# Access Compliance Report

## Public Rights-of-Way

Intersection ID: 32023	Main Street: CORNWALLIS_CAMP_DR	Cross Street: WESSYNTON_DR	Location: SE
ADA ID: A9E7811674C8	Ramp Type: BlendTrans2	Initial Pass/Fail: Fail	Overall Compliance: No
Severity Score: 8.75			
Codes/Mitigation Info/Possible Solution		Field Measurements/Component Compliance

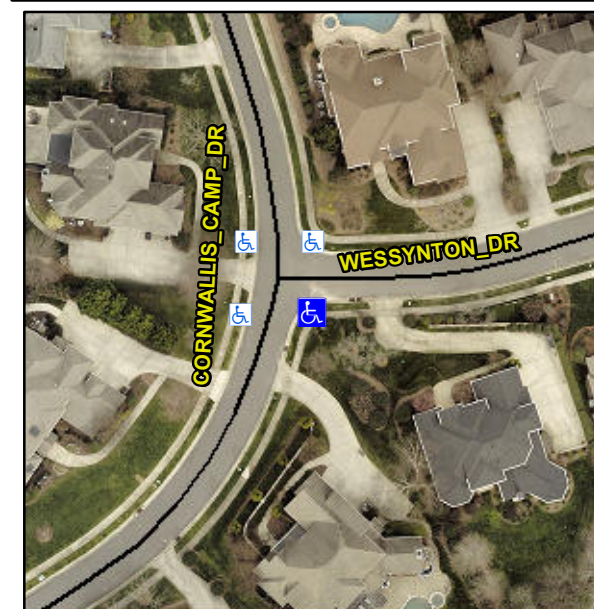
**Not Found, R304.5.1**

Compliance	Description	Data	Compliance	Description	Data
N/A	Ramp Length (in)	50.0	Yes	BlendTrans Slope (%)	3.3
No	Ramp Width (in)	40.0	Yes	BlendTrans XSlope (%)	1.2
N/A	Flare Type LT	N/A	N/A	Flare Type RT	N/A
N/A	Flare Slope LT (%)	N/A	N/A	Flare Slope RT (%)	N/A
N/A	Flare Traversable LT?	N/A	N/A	Flare Traversable RT?	N/A
N/A	Landing Length (in)	N/A	N/A	DWS Provided?	N/A
N/A	Landing Width (in)	N/A	N/A	DWS Contrast?	N/A
N/A	Landing Slope (%)	N/A	N/A	DWS Length (in)	N/A
N/A	Landing X Slope (%)	N/A	N/A	DWS Full Width?	N/A
N/A	Landing Curb? (Y/N)	N/A	N/A	DWS Offset (in)	N/A
N/A	Shared Landing?	N/A			
N/A	Gutter Ponding?	Yes	N/A	Gutter Slope (%)	N/A
N/A	Gutter Lip Ht (in)	N/A	N/A	Gutter X Slope (%)	N/A
N/A	Painted X Walk1?	No	N/A	Painted X Walk2?	No
	X Walk 1 Direction	To N		X Walk 2 Direction	To W
	X Walk 1 Width (in)	N/A		X Walk 2 Width (in)	N/A
	X Walk 1 Slope (%)	0.3		X Walk 2 Slope (%)	0.7
	X Walk 1 X Slope (%)	0.5		X Walk 2 X Slope (%)	2.4

N/A	Ramp inside XWalk1?	N/A	N/A	Ramp inside XWalk2?	N/A
	Road Slope (%)	3.1		Clear Space?	N/A
	Road X Slope (%)	1.1	N/A	Clear Space to XWalk (in)	N/A
N/A	Any Obstructions?	N/A	N/A	Storm Grate/Utility Hazard?	N/A
	Obstruction Type			Storm Grate/Utility Type	
		N/A			N/A
			Yes	Surface Condition? (G/P)	Good
			No	Curb Slope (%)	23.9

**Remove & Replace Curb Ramp With Two New Directional Ramps or Equivalent.**
